Memo

Subject: **Tekapo B Power Station tailrace weir and chute – condition assessment and review of bathymetric survey data**

The technical memorandum has been revised from the initial version dated 27 February 2026 following review and comments by Meridian Energy (Meridian) and Genesis Energy (Genesis). The summary document providing Genesis's comments is included in Appendix D of this revised version of the memorandum.

Meridian Response to Genesis Review Comments

Figure 2: Image of bay 4 between sills 4 and 5 on from bathymetric survey of Tekapo B Power Station tailrace weir and chute

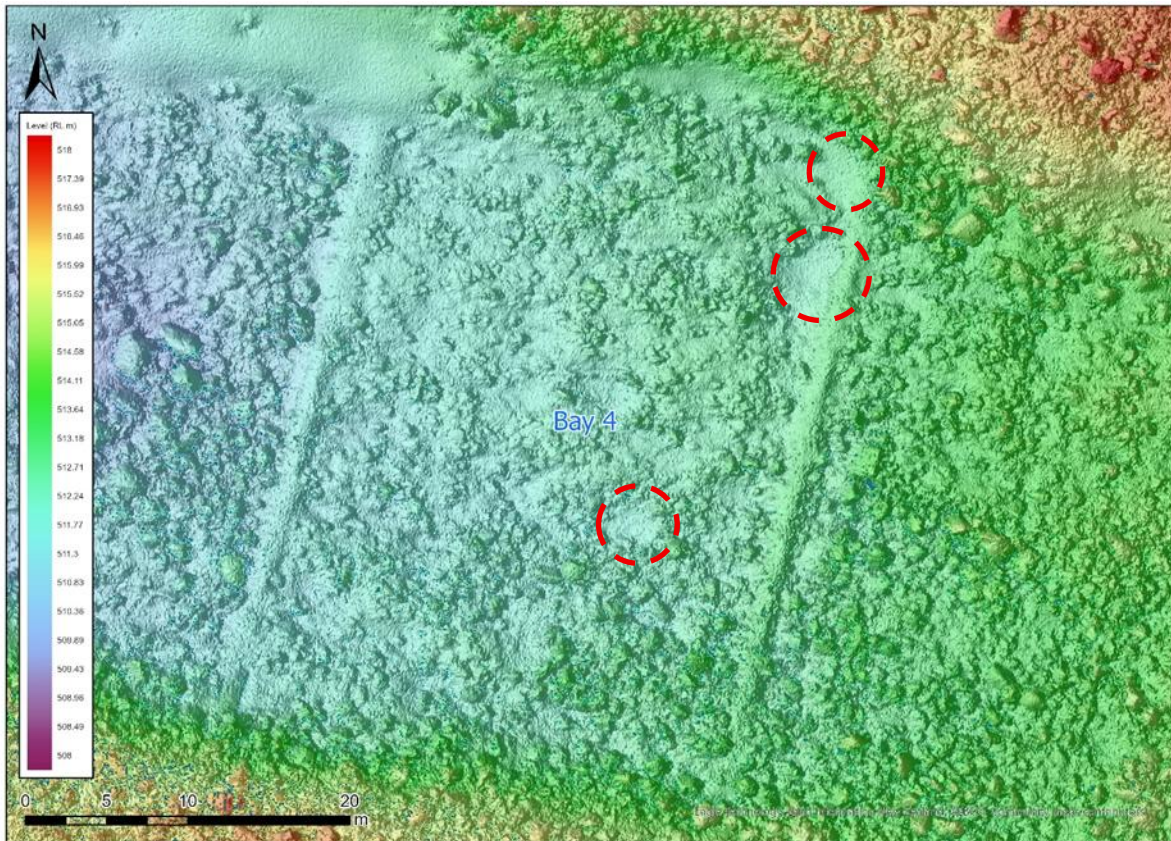
- Within bay 3, there appear to be areas of large riprap material (as large as the material in bay 2) interspersed with patches of smaller material.
- Within bay 4, larger riprap material continues to be present in clusters with smaller material filling the gaps⁴. There also appear to be some unknown ‘smooth’ patches (see red dashed circles in the image in Figure 2 below).

It was noted in Section 4.2.2 that the bathymetric survey showed up some unknown ‘smooth’ patches in areas of the riprap lining of the tailrace weir and rock chute structure. These are most noticeable in bay 4 between sills 4 and 5 as marked in the bathymetric survey image in Figure 2.

(A) LONG SECTION ALONG LEFT SIDE OF STRUCTURE
SCALE 1:1000 H
1:500 V

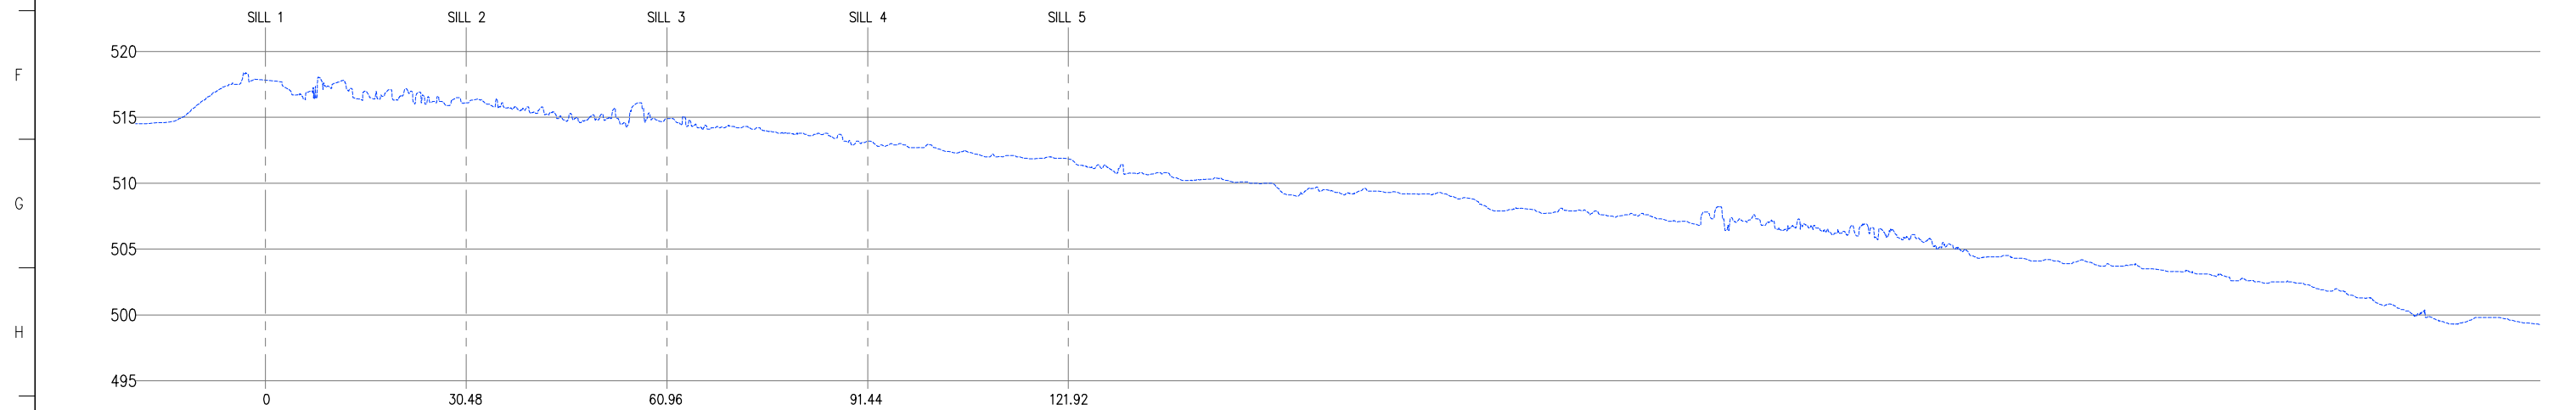
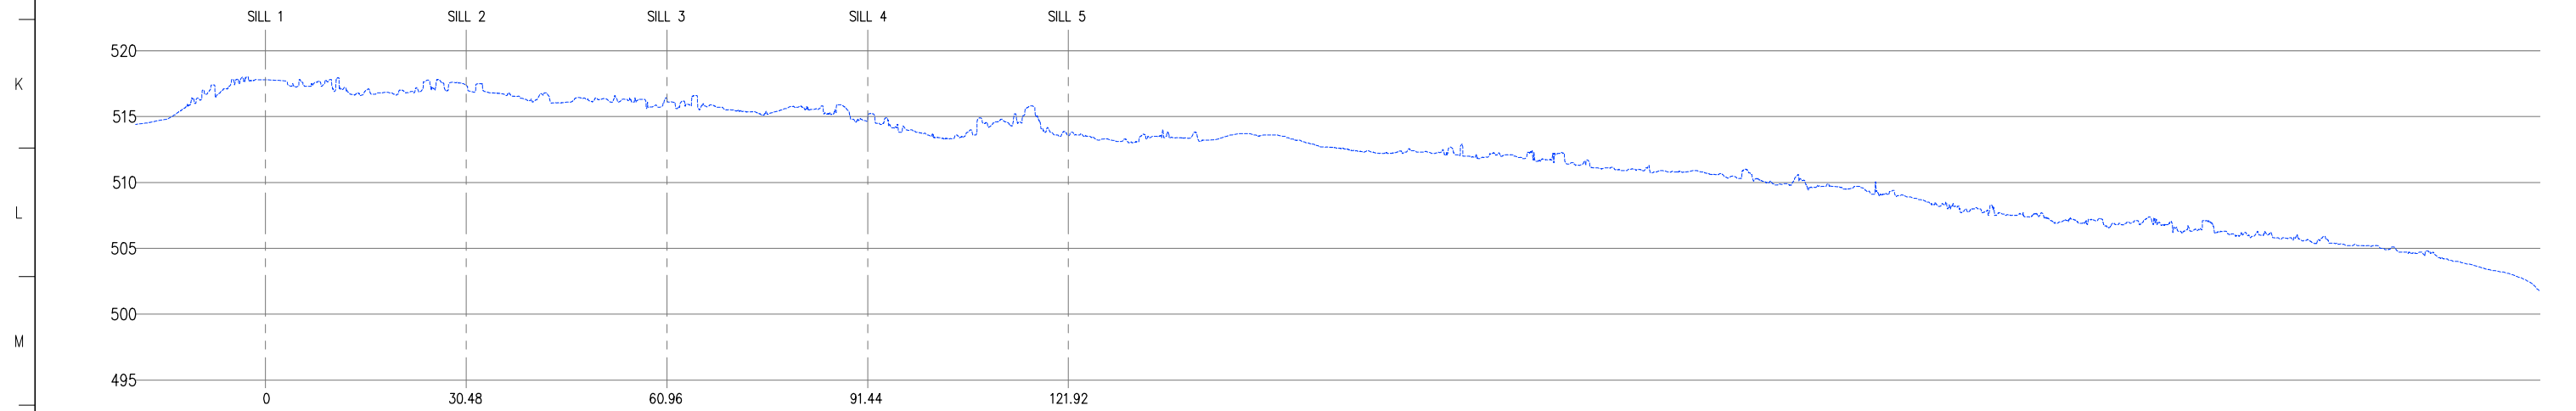
The long-section profiles of the tailrace weir and chute structure on drawing TEK-BTW\CHT\PROFILE SECTION sourced from the bathymetric survey data indicate that there has been minimal displacement of the riprap lining. There are no significant deviations from the constant 1 in 20 grade of the structure except for a dip along the right-hand side of bay 4 (refer to long-section C).

- There is no evidence of significant movement or erosion of the riprap lining.
- The riprap lining is generally flush or slightly proud of the concrete sills in each bay. This is supported by the evidence of the long-sections in drawing TEK-BTW\CHT\PROFILE SECTION.
